GEOTECHNICAL DESIGN BULLETIN NO. 2019-2

SUBJECT: Corrections and Additions to 2019 GDM
EFFECTIVE DATE: Immediately
SUPERSEDES: 2019 Geotechnical Design Manual – Additions and Revisions
RE: None

The Geotechnical Design Support Office is making the following Additions and Revisions (see attachments) to the SCDOT Geotechnical Design Manual (2019).

Figure 2-1, Bridge Embankment using Geotechnical Mitigation

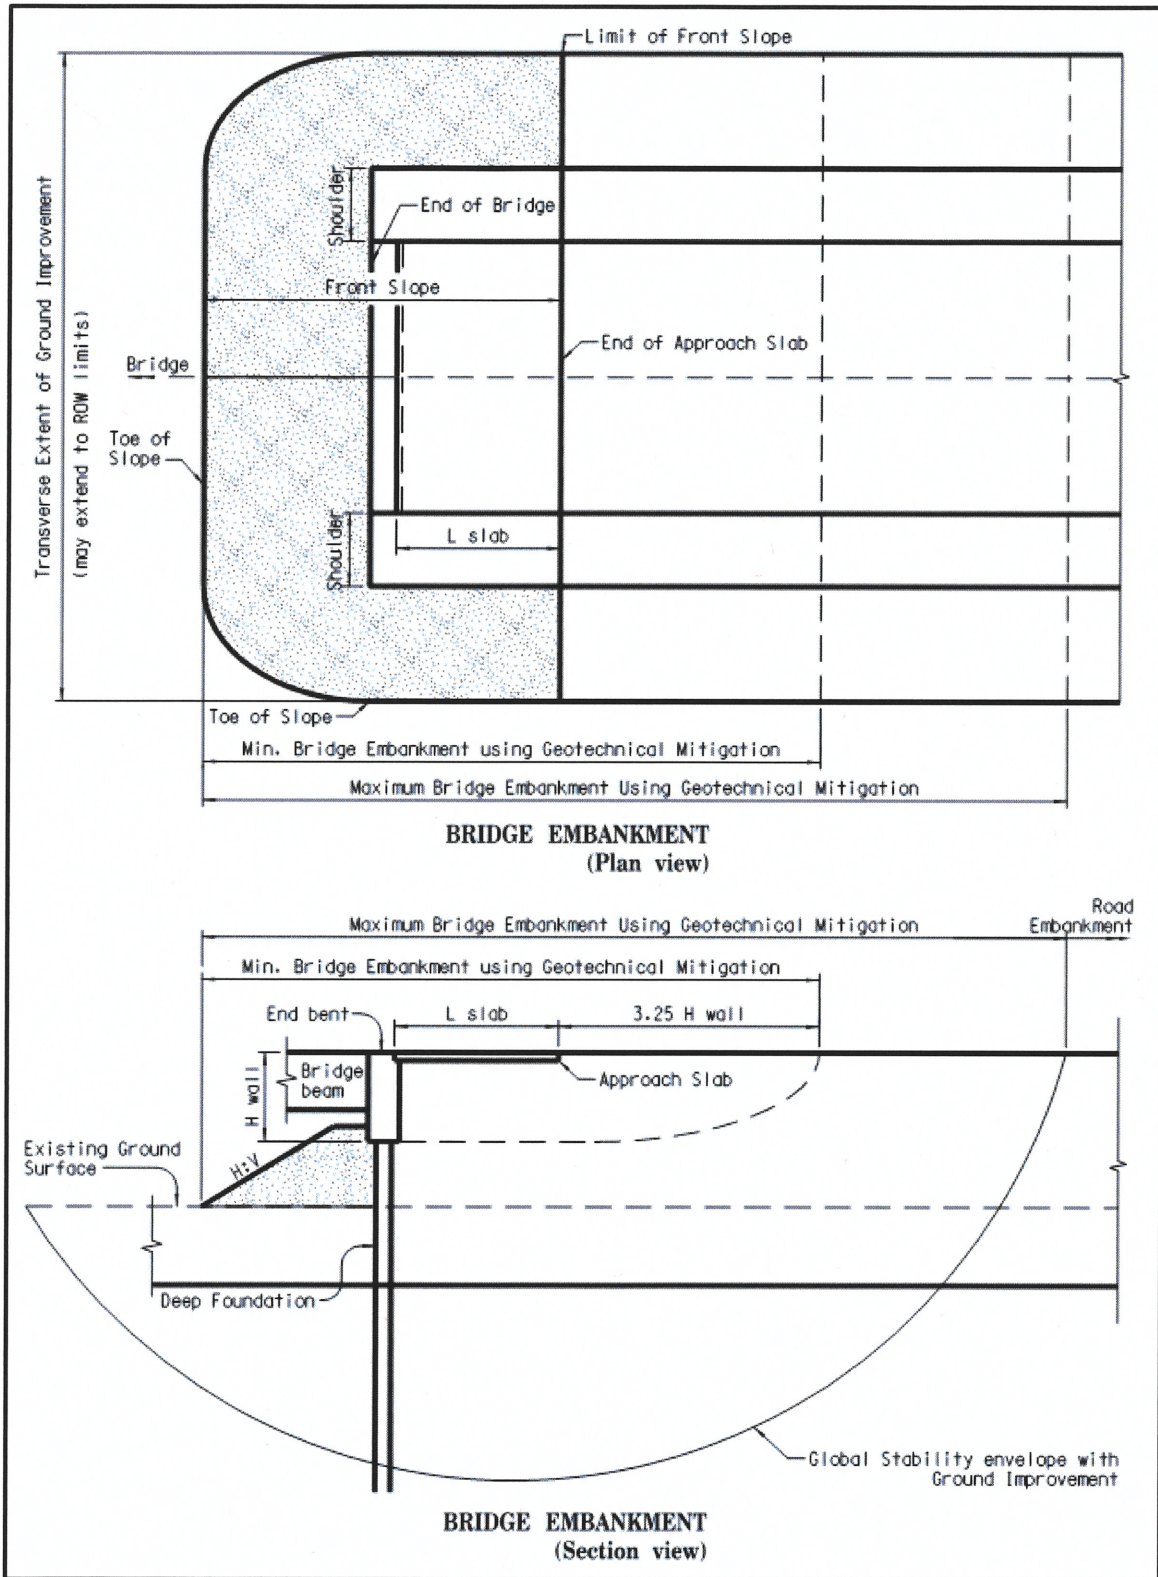
Geotechnical Mitigation Required: The Bridge Embankment shall include the front slope and shall extend from either the end of the front slope plus 3.25 times the height of the backwall measured from the end of the approach slab, if present, or to the point where the need for geotechnical mitigation terminates, whichever is longer (see Figure 2-1).

When ground improvement or ground reinforcement is used to minimize loads and deflections induced by global instability that occur during the Extreme Event limit state check from being transferred to the bridge structure. Typically geotechnical mitigation extends from either the toe of slope (see Figure 2-1) or outside of the toe slope and extends beyond the begin/end of bridge to a point where the global stability analysis surface exits the ground surface and achieves a resistance factor less than or equal to 1.0 ($\phi \leq 1.0$). If vertical elements other than the bridge foundation are used as the selected mitigation method, contact the PCS/GDS for further guidance. Further, geotechnical mitigation is typically limited transversely by the Right-of-Way lines. If geotechnical mitigation is only required to maintain stability in the transverse direction for the Extreme Event limit state check, the longitudinal extent of transverse mitigation shall be limited to the end of the front slope plus 3.25 times the height of the backwall measured from the end of the approach slab, if present.

Figure 2-2, Bridge Embankment using Structural Mitigation

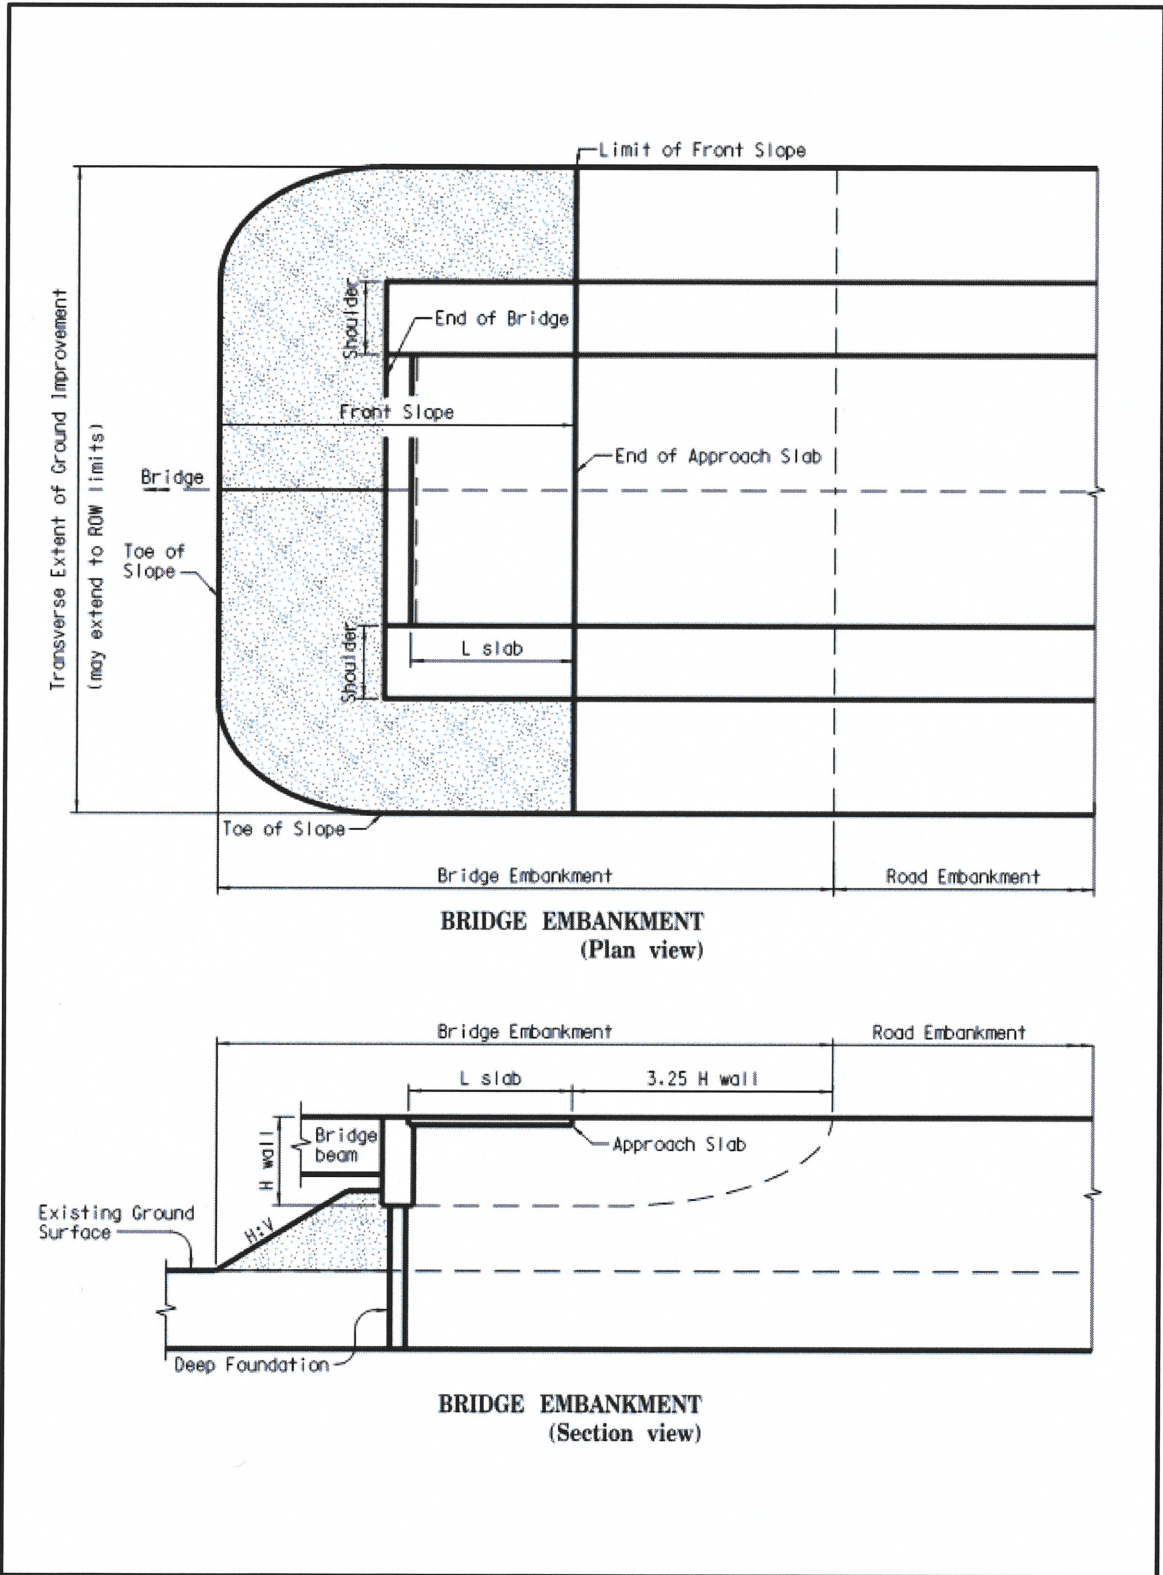
Structural Mitigation Required: The Bridge Embankment shall include the front slope plus 3.25 times the height of the backwall measured from the end of the approach slab, if present (see Figure 2-2). This distance shall be taken as the minimum Bridge Embankment.

In the event mitigation is not required for the Extreme Event limit state global stability analysis, the Bridge Embankment shall include the front slope plus 3.25 times the height of the backwall measured from the end of the approach slab, if present (see Figure 2-2).
